# Wizards Workshop

TEKTRONIX INTERNAL USE ONLY

April 18, 1980  
Issue 10-8

DC RESTORATION AND GAIN CONTROL  
SCHEMATIC 3

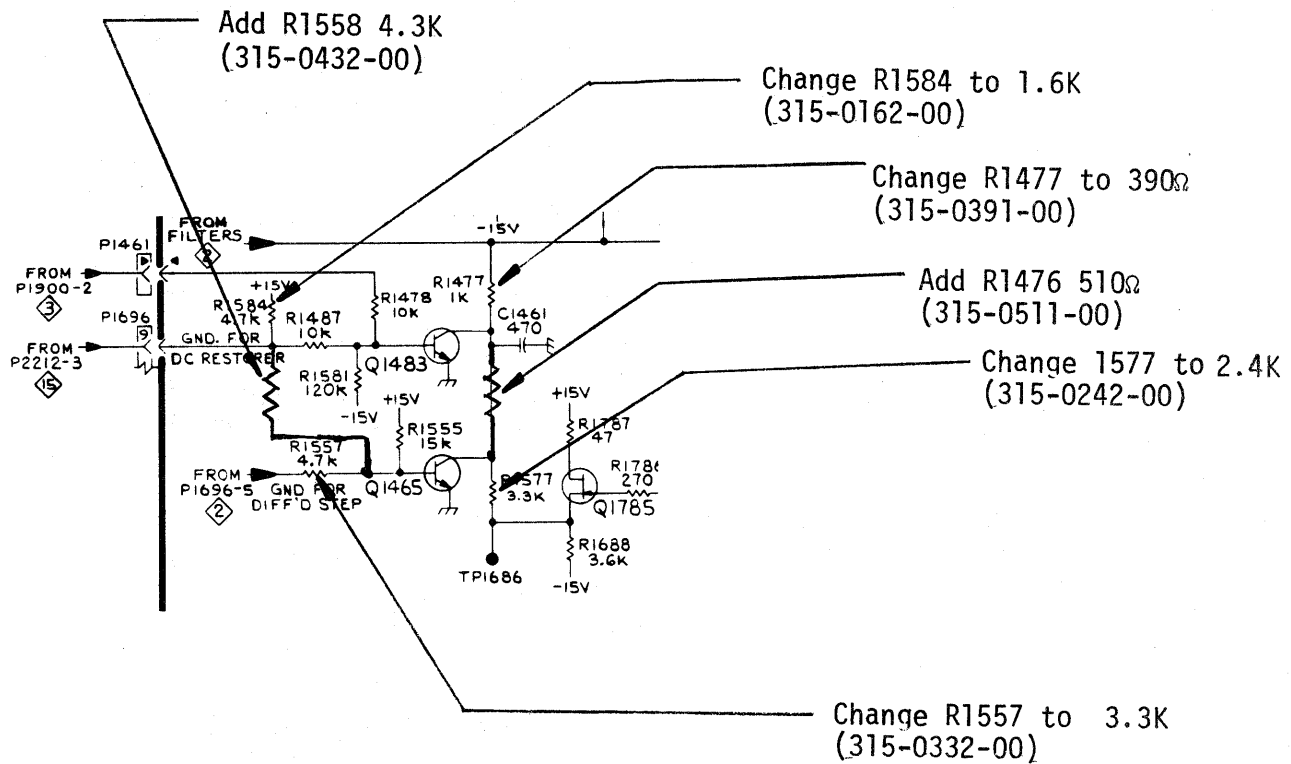
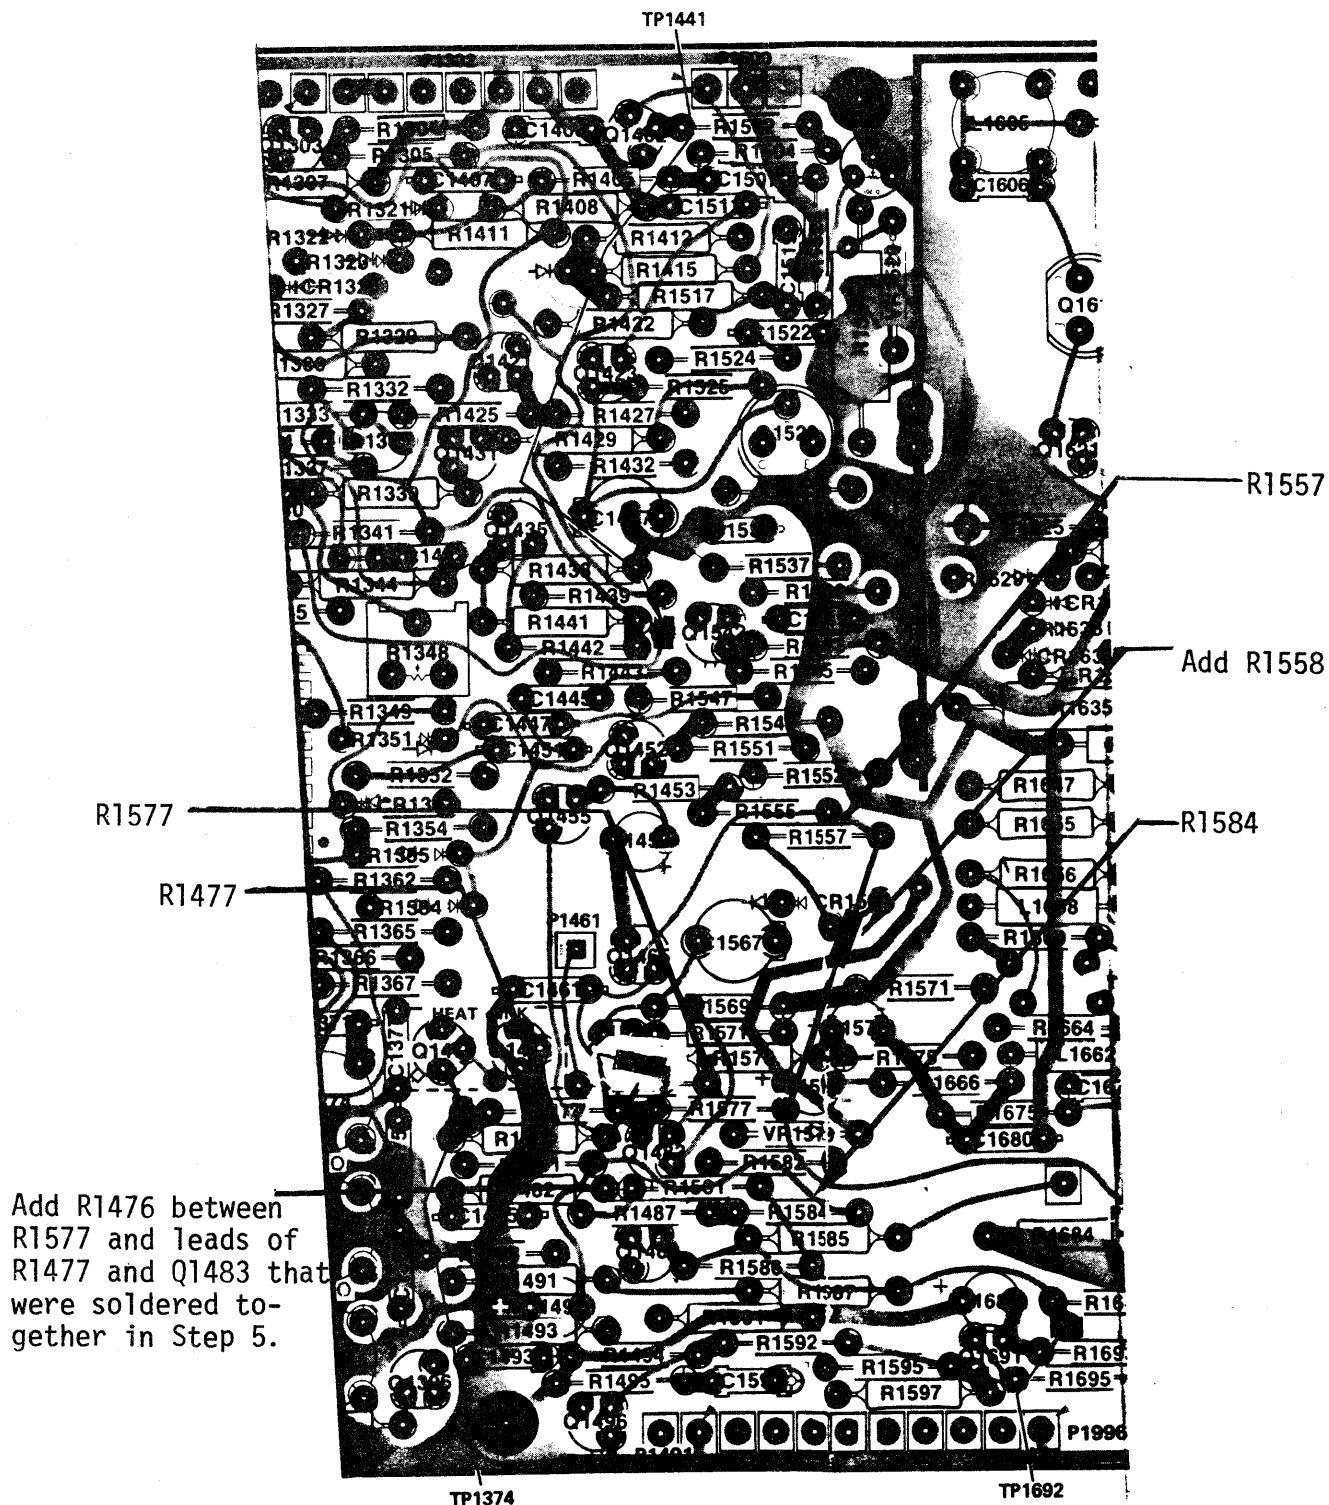
In the 1480C/1480R series waveform monitors, when the D.C. Restorer off button is pushed the restorer circuitry is not completely disabled. To check for this malfunction a slow ramp (period greater than 5 seconds) from an FG501 or equivalent is used. Set the controls to: Channel A or A-B, DC coupling, DC restorer off, and the field sweep. Center the trace on screen. Apply the ramp signal to channel A and adjust for a signal that will move the trace up and down approximately full screen. If the unit has the problem the trace will move up close to mid-screen, stop momentarily, and then jump up to correct level and continue moving to top screen.

1. Change R1557 from 4.7K to 3.3K (315-0332-00)
2. Change R1584 from 4.7K to 1.6K (315-0162-00)
3. Add R1558, 4.3K (315-0432-00) between the junction of R1557 - R1555 and the junction of R1584 - R1487.
4. Change R1477 from 1K to 390 ohms (315-0391-00)  
When changing R1477, leave the end of R1477 that was connected to R1577 lifted.
5. Lift the collector lead of Q1483 out of the socket and solder it to the lifted end of R1477.
6. Change R1577 from 3.3K to 2.4K (315-0242-00).
7. Add R1476, 510 ohms (315-0511-00) from the junction of R1577 - C1461 - Q1465 to the junction of R1477 - Q1483 that was soldered in Step 5.

FIG. 2 CHASSIS, C-51 SERIES  
PARTIAL VIEW

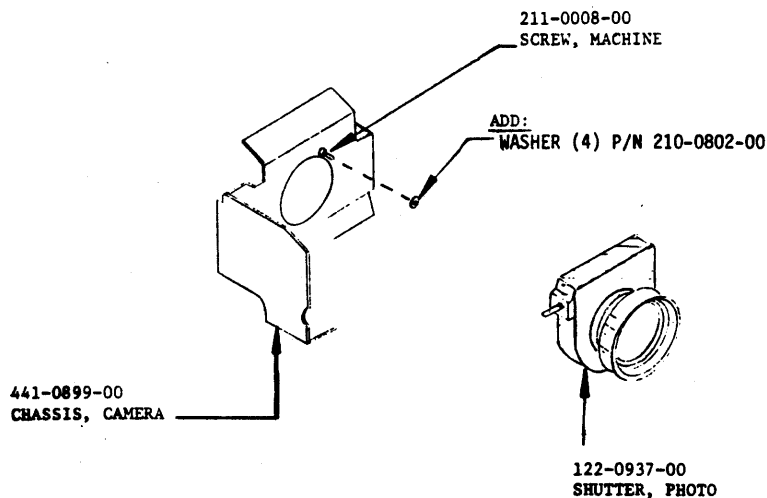
The C-51 camera focuses at or near the end of adjustment. To allow focusing at the center of adjustment, add \*4 flat washers, P/N 210-0802-00, between the photo shutter and camera chassis. The washers move the shutter forward, increasing the adjustment range.

<u>Quantity</u>	<u>Part Number</u>	<u>Description</u>
* 4 Each	210-0802-00	Washer, Flat, STL (.15ID X .032THK, .3120D)

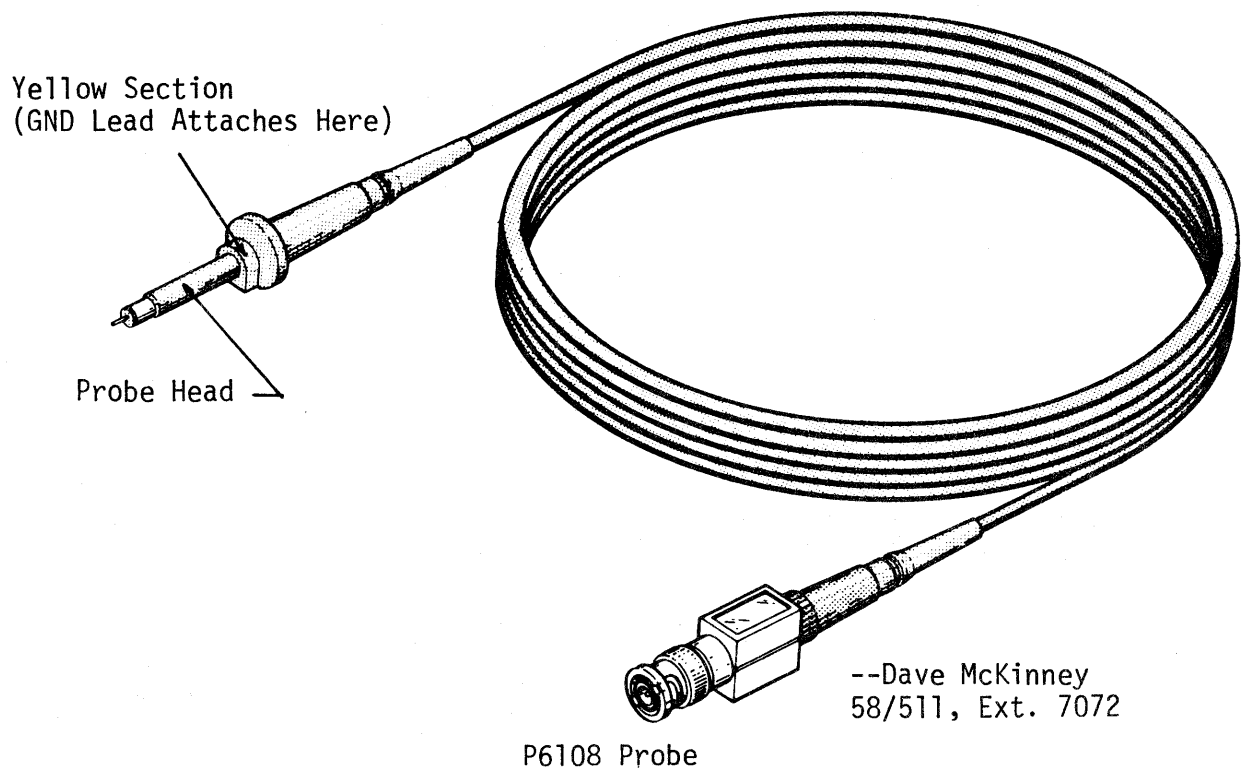
The difference between a standard P6108 and the hybrid version is on the probe head assembly. \*The ground lead for the probe, snaps into a yellow section on the probe head. There are letters on the top side of this yellow section. The standard version P6108 has white letters and the hybrid version has black. This is the only nonevasive visible difference. When a Service Center replaces a defective probe head assembly P/N 206-0225-00, PLEASE SEND ALL HYBRID VERSIONS TO ME FOR FURTHER EVALUATION.

4025/27 Processor Board Battery Circuit

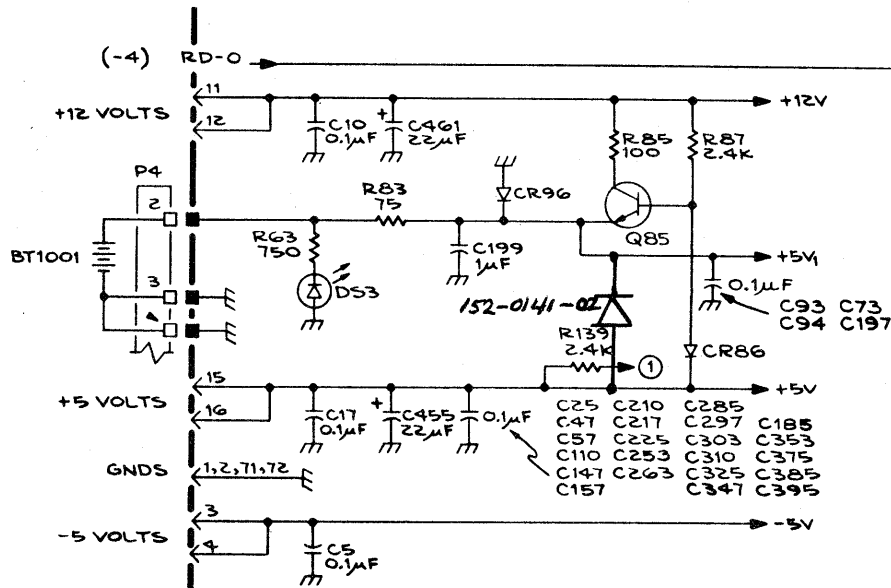
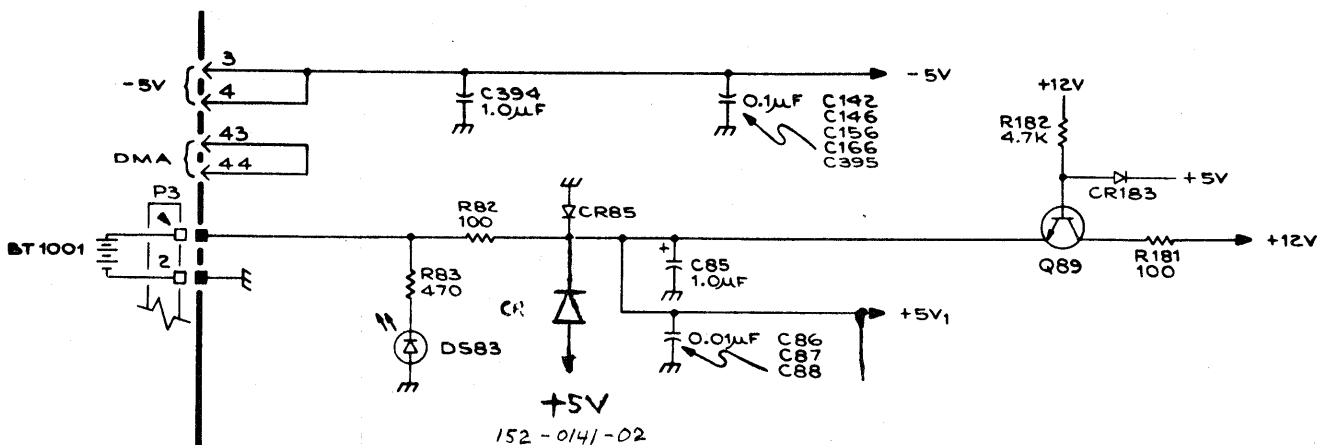
The discharged battery will cause the 5V supply to the C-MOS RAM to drop below 4 volts on power up during the 30 msec delay it takes the +12V supply to come up after the 5V supply. The lowered Vcc voltage to the C-MOS RAM will cause the terminal to lock up. The battery circuit Mod will clamp the Vcc pin (+5 V1) for the C-MOS RAM so it will not drop below 4.4V during power up.

1. Connect the cathode side of diode 152-0141-02 to the pad which connects R88, R90, R92, C93, C94, R95 and CR96 together.
2. Connect the anode side of diode 152-0141-02 to the cathode side of CR86. The side closest to the edge of the circuit board.

1. Connect the anode side of diode 152-0141-02 to the anode of CR185.
2. Connect the cathode side of diode 152-0141-02 to the top of R186. Face edge connector towards the left and components facing up.

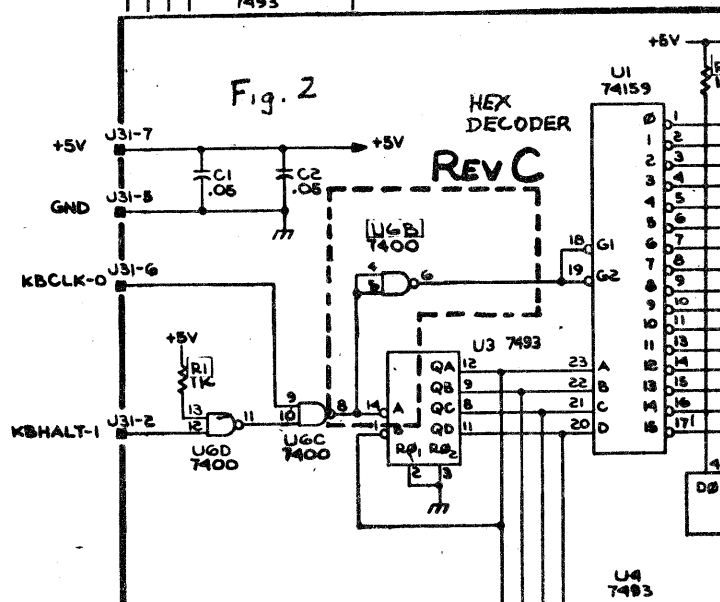
There are a few REV B level (Figure 1) keyboards installed in the 4051/52/54 Graphic Systems, which are incorrect. They should be REV C (Figure 2) keyboards. The problem that occurs is if two keys are pressed at once a string of characters will write across the screen with the REV B level keyboards. If this happens check the level of the keyboard. The location of this label is on the upper right hand corner of the keyboard under the label CHERRY.

1. Cut the run on top of the REV B keyboard that comes off of pin 18 and 19 of U1. (Figure 1)
2. Strap pin 18 and 19 of U1 to pin 6 of U6. (Figure 2)
3. Strap pins 4, 5 and 8 of U6 together. (Figure 2)

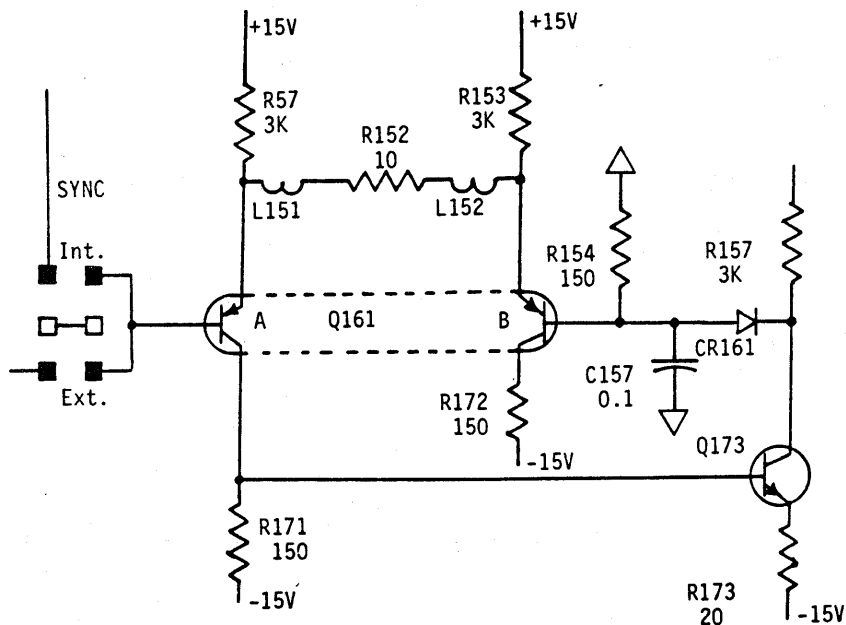
A herringbone pattern has sometimes been noted on copies produced by the 4632 Option 6 instrument. This effect is especially evident with a five to ten megahertz resolution signal such as that available from the 067-0690-00 and -01 test fixtures. The cause for the pattern is an oscillation of about 750 megahertz in the vicinity of Q161. The oscillation may diminish or disappear when an oscilloscope lead is connected to either end of R152.

To correct this, Mod #39499 calls for two toriodal ferrite beads to surround the leads of R152 and suppress high frequencies. These beads, L151 and L152, are part number 276-0507-00. A partial schematic illustrating their location is given below.

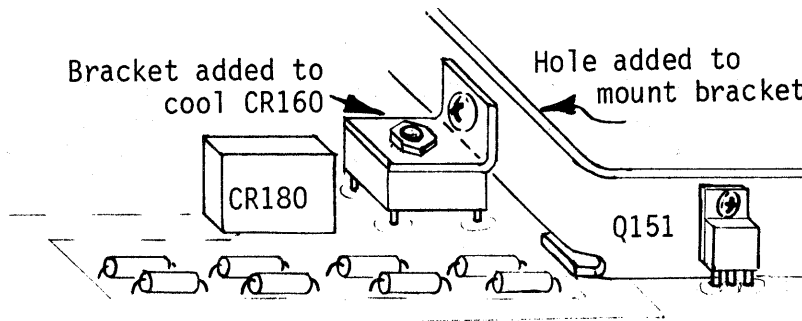
To assist the cooling of CR160, a bracket has been added as shown in the figure below. A mounting hole has also been added to the mainboard bracket.
